**Watts Bar Unit 1 Nuclear Power Plant Corrective Actions
for Generic Letter 2004-02**

Figure 1: Schematic Diagram of a Stacked Disk Strainer Module

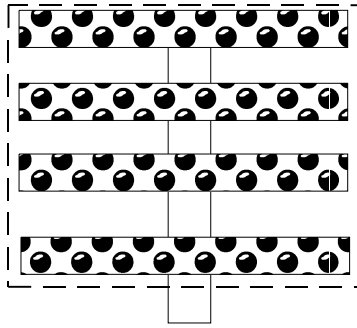
The staff identified a nonprototypical condition affecting only the second informal experiment described above, during which the test debris was manually piled around the test strainer. During this experiment, the form of the debris bed changed from a thin, uniform covering over the entire strainer surface to a circumscribed accumulation that engulfed the majority of the strainer module.

Based upon observations at various vendor facilities, the staff has found that the strainer circumscribed velocity (i.e., the volumetric flow rate through a strainer divided by its circumscribed area) and the strainer surface approach velocity (i.e., the volumetric flow rate through a strainer divided by its total surface area) may not be capable of being prototypically scaled simultaneously for all replacement strainer designs. A schematic diagram highlighting the distinction between circumscribed area and total surface area for a conceptual stacked disk strainer module similar to the Watts Bar design is provided below for clarity:

In the diagram above, the horizontal rectangles with dark circles represent square-faced disks of perforated plate. The vertical rectangle represents an unperforated pipe that collects the flow that has passed through each strainer disk. The total strainer area of this module is the total surface area of the square disks of perforated plate. For the given module geometry, the total circumscribed area is considered to be the surface area of an imaginary box drawn around the stack of perforated disks, represented by a dotted line in the above figure.
